NOTICE: This long block utilizes head studs in place of the factory head bolts. Machining and clearance of the lower rocker box cover **is required** to provide clearance for the head stud and nut. Failure to machine the necessary clearance will result in an interference with the head stud, resulting in a rocker box that does not fully seat with the cylinder head, allowing for an oil leak to occur. Clearance the rear most portion of the rocker box cover around the stud location identified using a 1" end mill as shown in the images below.

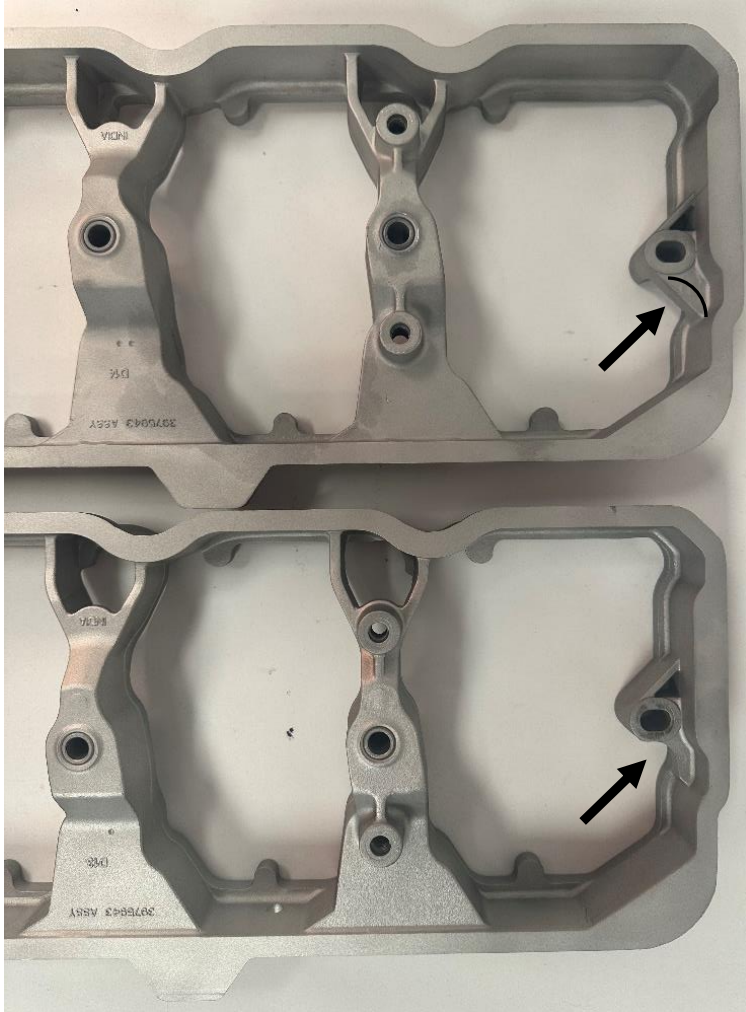
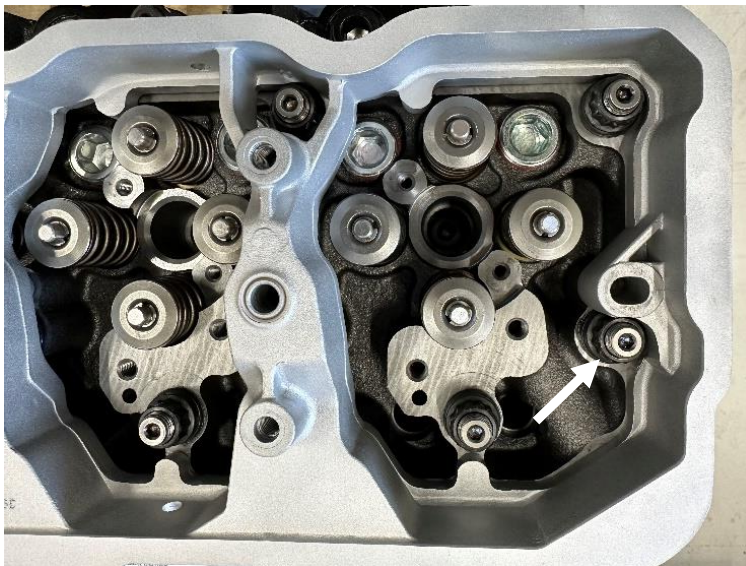
Original lower rocker box with clearance area outlined.

Modified lower rocker box cover with clearance around the rear center stud location.

Installed rocker box with clearance around the rear center stud and nut.
